GOVERNMENT OF THE DISTRICT OF COLUMBIA
DEPARTMENT OF TRANSPORTATION

MEMORANDUM

SUBJECT: BZA Case No. 18671 – Takoma Park Square 3357 – 6923 Maple Street and 6919-6926 Willow Street N.W.

Figure 1 On-Street Block Face Map (Grove/Slade)

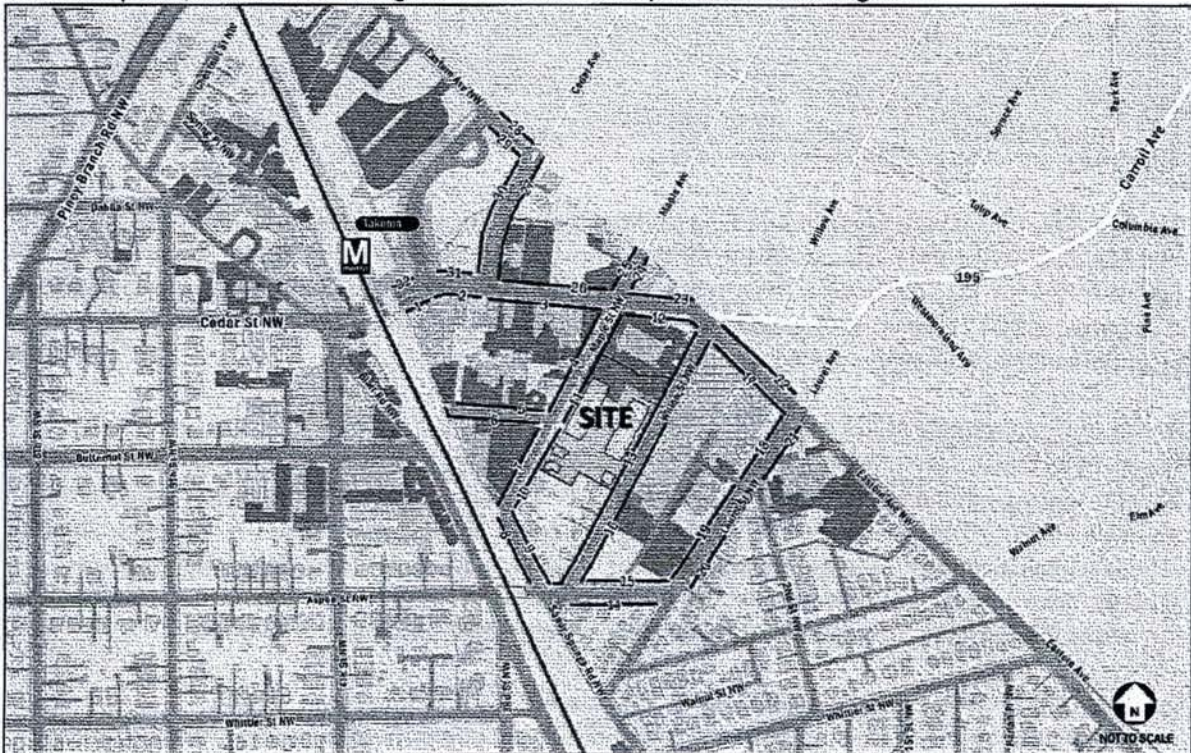
The Applicant’s analysis of weekday on-street parking included the following blocks in the study area as seen in Figure 1: Block Face Map. Based on the Applicant’s report, there are a total of 186 parking spaces in the study area, of which 83 are subject to Residential Permit Parking (RPP) restrictions, 90 are metered spaces, and the remaining 15 are unrestricted spaces as seen in Figure 2.

Figure 2 Summary of Parking Type (Source: Gorove/Slade)

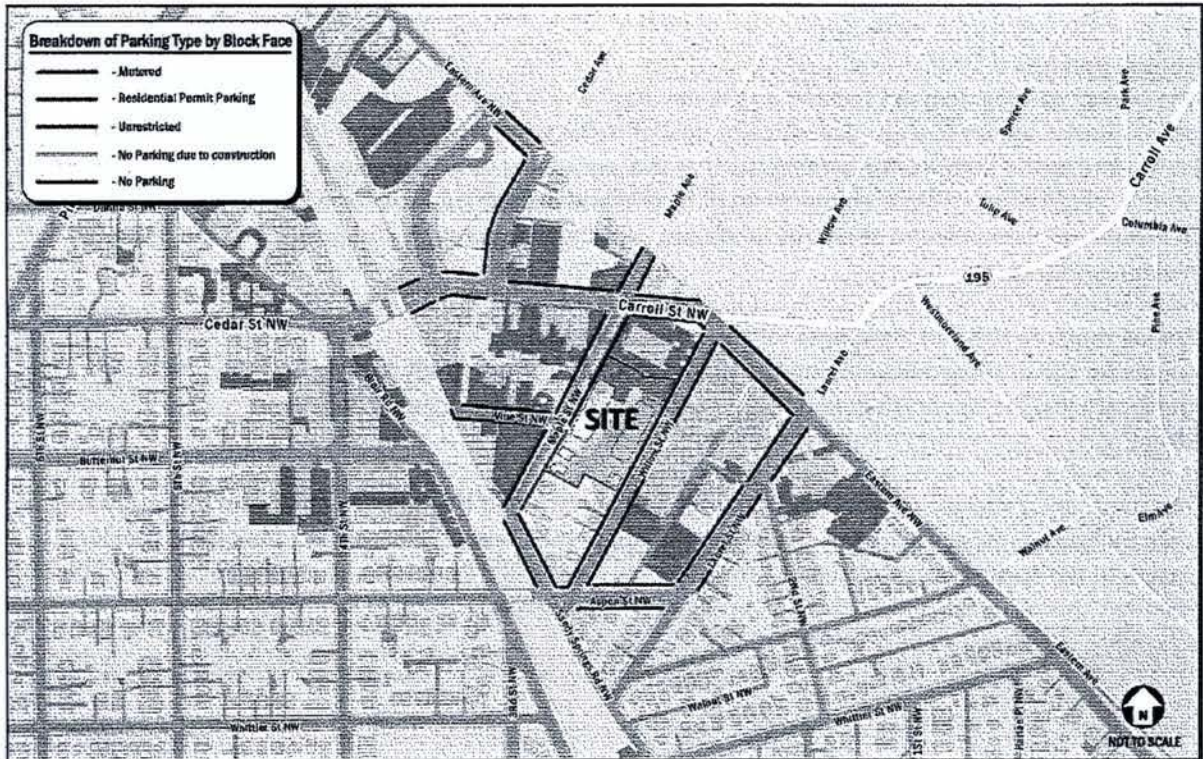
The inventory of available on-street parking facilities was conducted on Tuesday, January 28, 2014 from 6:00 AM to 9:00 AM and from 4:00 PM to 9 PM. A survey conducted by the Applicant found that the highest utilization rate occurred at 8PM at a rate of 59%. This peak parking period had an occupancy of 110 spaces. DDOT agrees that on-street parking in the vicinity appears sufficient to accommodate potential spillover parking on weekdays.
